## **DRAFT - Lodi Township Planning Commission Meeting Minutes**

Subject: Update on Ann Arbor Baptist Church Addition, 2150 S Wagner Road (Parcel # M-13-02-100-007), Combined Preliminary & Final Site Plan

**Subject: Ann Arbor Baptist Church Addition, 2150 S Wagner Road (parcel # M-13-02-100-007),  
Combined Preliminary & Final Site Plan Review**

Overhead View of Proposed Stormwater Basin Location:

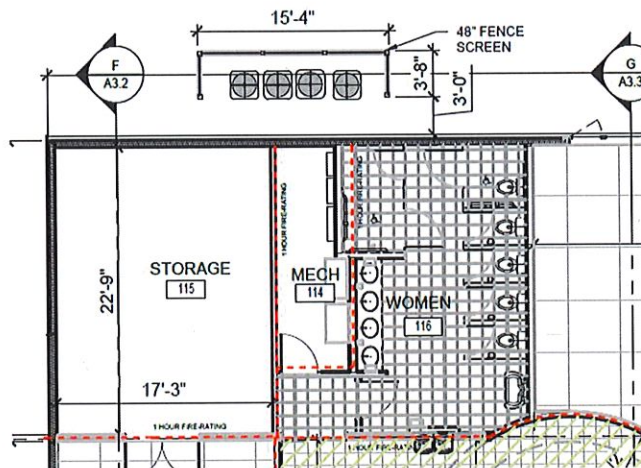
The existing vegetation and topography provide natural screening from the right of way (Wagner Rd). The southeast corner of our lot has a tree line just inside the road easement and the open section between the tree line and the driveway is at a much lower elevation than the proposed stormwater basin. From the road the finished basin (east side of the bowl) will appear to be natural terrain and the stand pipe will not be visible (see yellow sketched lines of sight). However, we are proposing that the required screening green belt will wrap around the "front" east side to ensure that the basin is completely screened from the roadway regardless of the elevation change. The blue lines of sight illustrate that our property already has complete natural screening to the south (bordering neighboring agricultural field) and to the west (our woods). Based on the provision 55.09.J.2 we are asking that the south tree line be considered pre-existing natural screening to eliminate the greenbelt requirement along that side of the stormwater basin. The green line depicted on the above overhead shot illustrates the greenbelt that we are proposing which will be over 20 feet wide and will have 1 tree and 3 shrubs for every linear 15 feet as measured along the greenbelt's centerline. Below is a screenshot from the updated landscape plan showing this landscaping.

proposing to save this tree as we feel that the reshaping of the earth around it is far enough away that it will not impact its health, and the cottonwood is known to thrive in areas with high moisture, such as riverbanks, floodplains, or near streams. They have a high tolerance for wet soils and can even handle periodic flooding, making them a good fit for consistently moist or seasonally wet areas. We do not believe that the stormwater basin will be holding water regularly except potentially in the spring after snow melt or after very heavy rains.

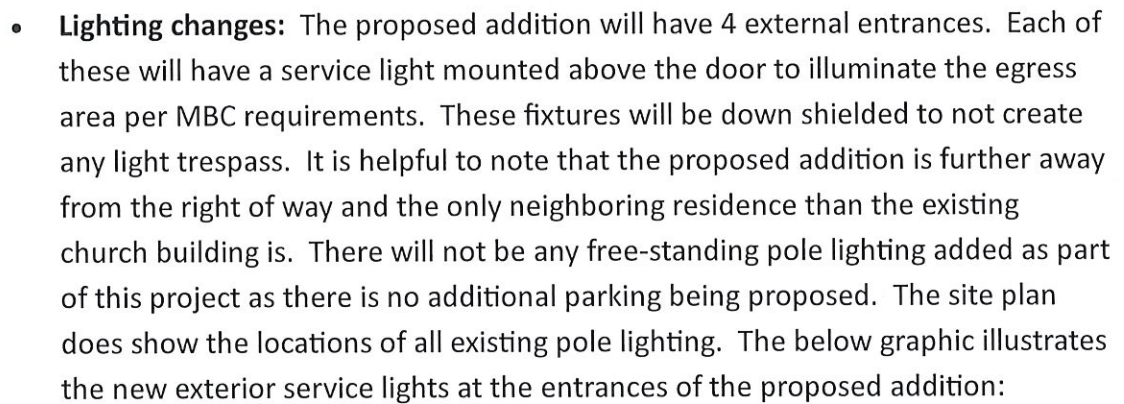
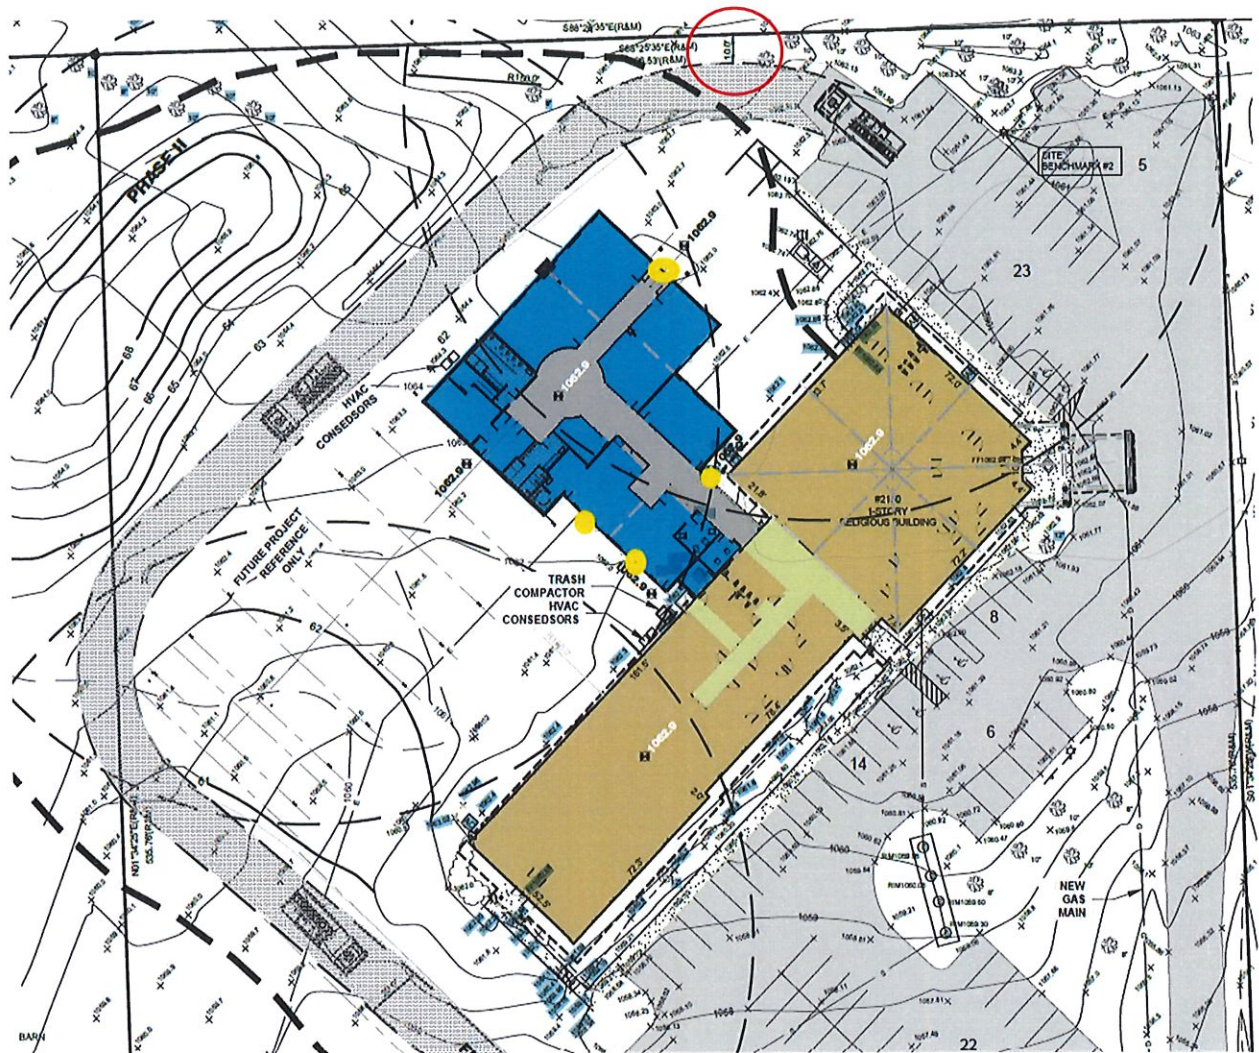
- **Mechanical equipment screening:** Our site plan includes two areas that will require screening around mechanical equipment. The first area is on the west side of the addition where there will be four air conditioning condensers set on a concrete pad. Our site plan has been updated to include fencing around these units as shown in this screenshot:

The second area is between the existing building's south wing and the proposed new construction. There will also be 4 air conditioning condensers and a trash collection area. These items will all be screened as depicted below and on the site plan:

- Driveway setback for fire truck access road:** We submitted an updated site plan that pulled the drive away from the north lot line and resolved the setback issue (10 feet minimum) of the fire drive. This was submitted prior to the June Board or Trustee's Meeting, and should be considered as a resolved issue. See the above screenshot that also illustrates this update (circled in red).

3. **Mechanical Equipment.** The applicant has provided additional information on mechanical equipment screening, as requested. These include air conditioning condensers and a trash collection area. The applicant is proposing a 4-ft. fence screen around these areas. This is sufficient screening for these units.
4. **Lighting.** The applicant has clarified that there will be four external entrances with the building addition, which will each have a service light mounted above the door. They have indicated that these lights will be down-shielded. There is no proposed freestanding pole lighting with this addition. This information is sufficient for our requested clarification and meets the ordinance.

## STORM WATER LANDSCAPING

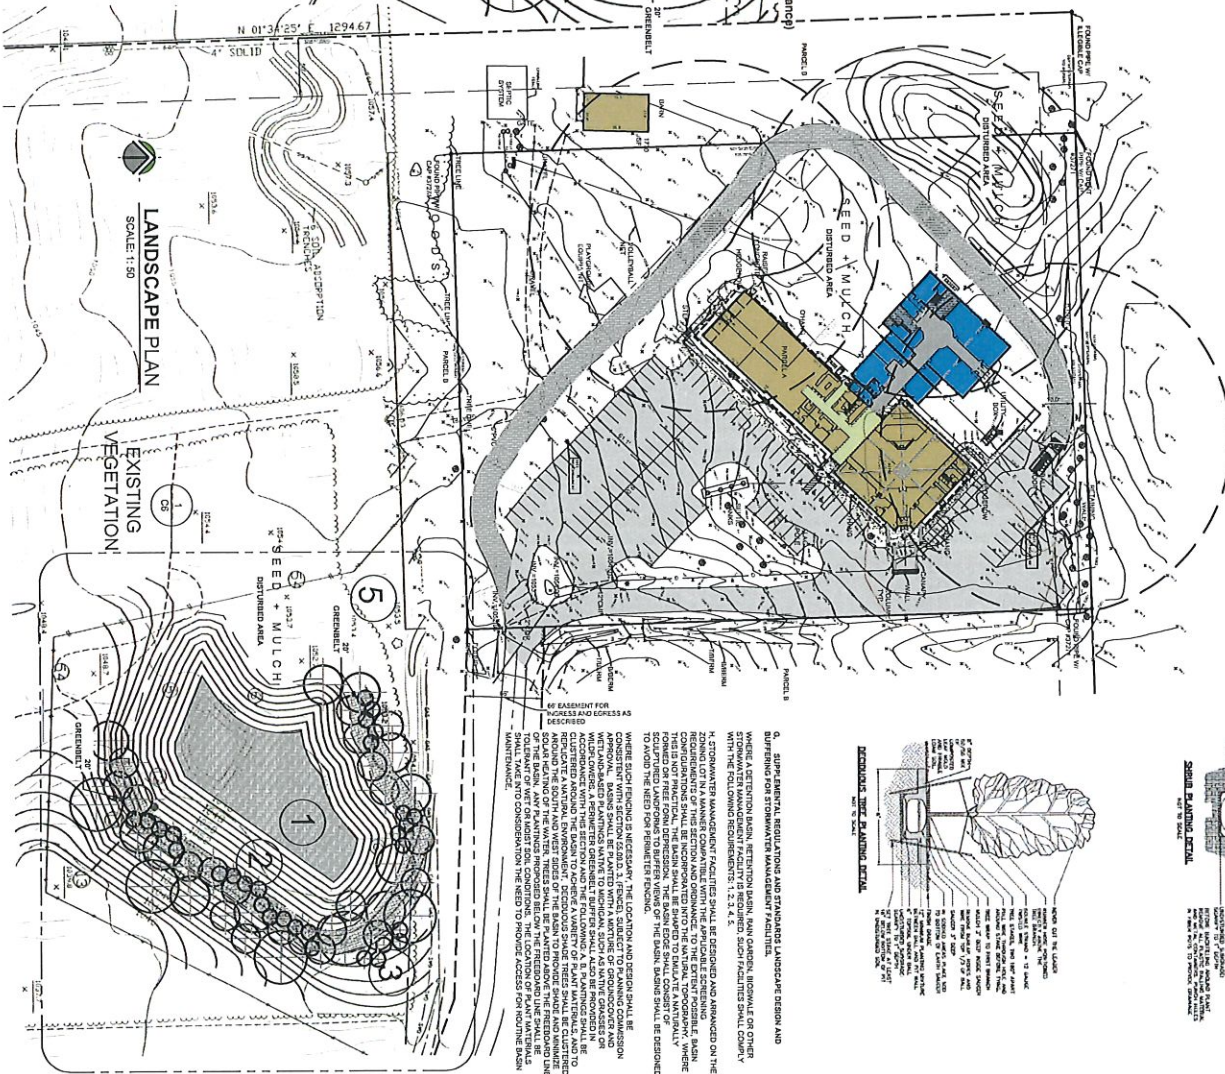
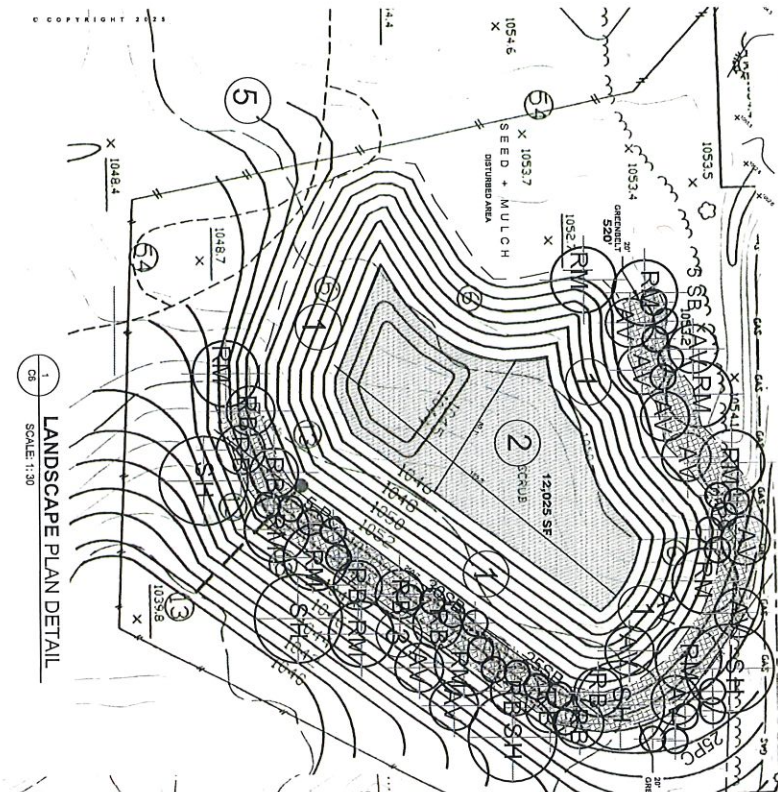
GREEN BELT = 520' / 30015' = 105 SCRUBS PROVIDED

Aerial photo of Ann Arbor Baptist Church site. Existing wooded area at the southwest corner of the site and existing tree line along the southern property line and southern portion of lot frontage on Wagner Road.

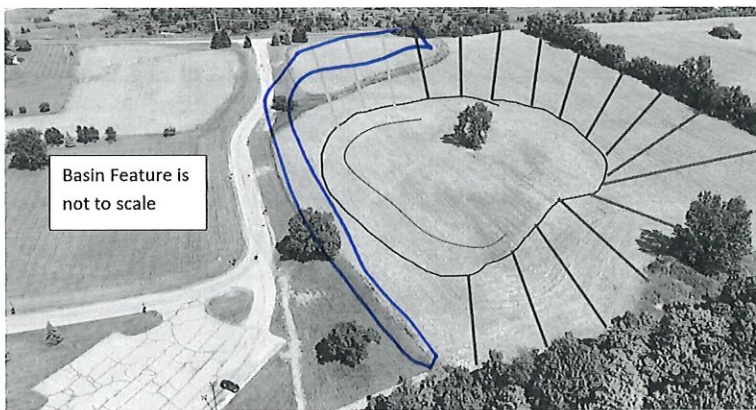
- 1. Landscaping Plan for Stormwater Detention Facility.** A perimeter greenbelt buffer is required around a stormwater detention facility providing one (1) tree and three (3) shrubs per 15 linear feet. The applicant is proposing to provide the required greenbelt for a portion of the stormwater facility, and use existing conditions to satisfy the rest of the requirement.

Existing Conditions: There is a wooded area on the southwest portion of the parcel, which is directly west of the proposed detention basin. There also appears to be an existing tree line along the south property line, which is directly south of the proposed detention basin. There also appears to be a tree line along the very southern portion of the lot frontage along Wagner Road. The applicant is requesting that this existing vegetation be used to satisfy the screening requirement for the detention facility. Figures below show existing conditions and graphic provided by the applicant. *Section 55.09.J* of the Zoning Ordinance allows the Township Board to determine that landscaping requirements have been satisfied by existing vegetation and topography.

Proposed Planting: For the areas of the proposed stormwater facility that do not have existing vegetation, the applicant is proposing plantings in line with the ordinance requirements. This includes along the entrance drive into the Church (along the northern portion of the

detention basin). It appears the applicant is also proposing to provide screening along the portion of the pond visible from Wagner Road that does not have an existing tree line. The applicant has indicated that the total area that is not screened by existing vegetation is 520 linear feet, which would require 35 trees and 105 shrubs. The applicant is proposing 36 trees and 115 shrubs.

If the Township Board finds that the existing conditions along with the proposed plantings are sufficient to meet the required landscaping, it may approve the landscaping plan as proposed.
